INSPECTION REPORT

RICKER GARDENS

NR 509 FOREST AVE.

CITY OF PORTLAND, MAINE
DEPARTMENT OF BUILDING INSPECTION
PUBLIC ASSEMBLAGE INSPECTION REPORT
FOR

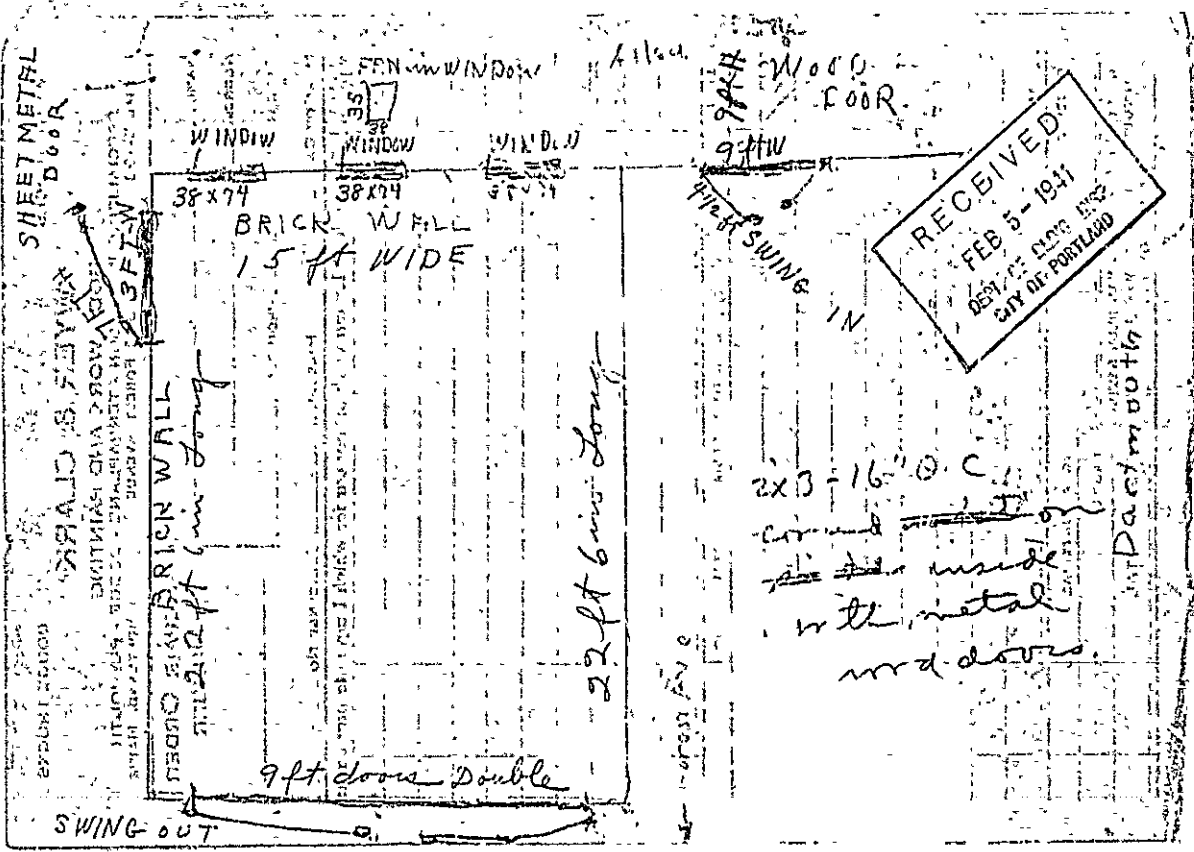
1. The partitions setting off this spray room in the corner of the building may be of 2x5 studs, set vertically not more than 16 inches from center to center, but these studs must be covered tightly on both sides with incombustible wallboard such as Gypsum board or on both sides with new galvanized metal, instead of the metal covering on one side indicated in your application for the permit. The idea of this protection is to provide a fire resistive enclosure without openings in it so that in case of a "flash" in the spray room there will be no inflammable vapor in the main building outside and the fire cannot spread to the outside of the room. For this same reason the doors from the main building into the room should fit tightly, should be solid doors and must always be closed when the room is in use.

2. Artificial lighting must be by electricity, no extension lights or cords of any description are permitted in the room, and all fixtures and lights are required to be explosion-proof.

3. The exhaust fan which you have shown in the outside wall is required to have the bottom of the opening through which it exhausts air not more than five feet above the floor of the room, the motor is required to be spark-proof and the size of the fan should be such that there will be a complete change of air in the room every three minutes when the fan is in operation.
